I object to application HGY/2023/0717 to fell two Lawson's Cypresses at the entrance to 65 North Road, N6.

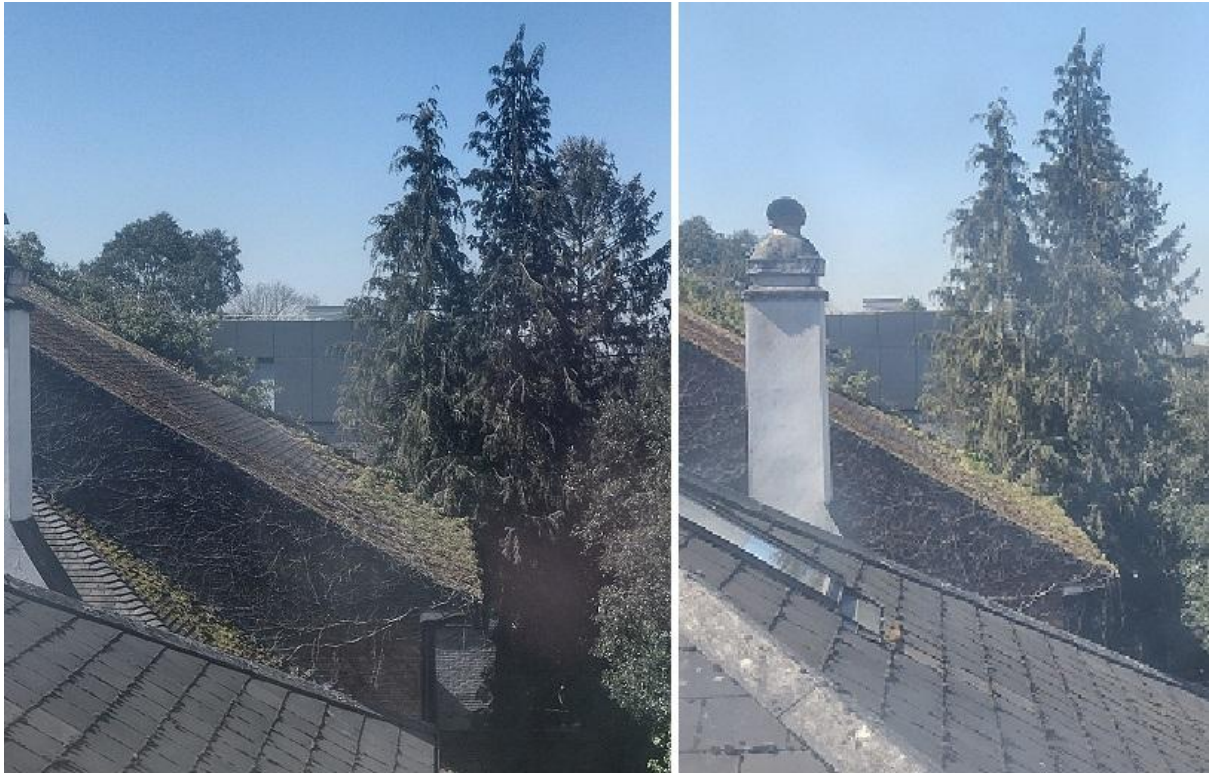
2. Second, the map provided is completely inaccurate. As in some previous applications, the applicant has left out some of the buildings most directly affected by his proposals, including No 59 North Road.

The correct layout is as below:
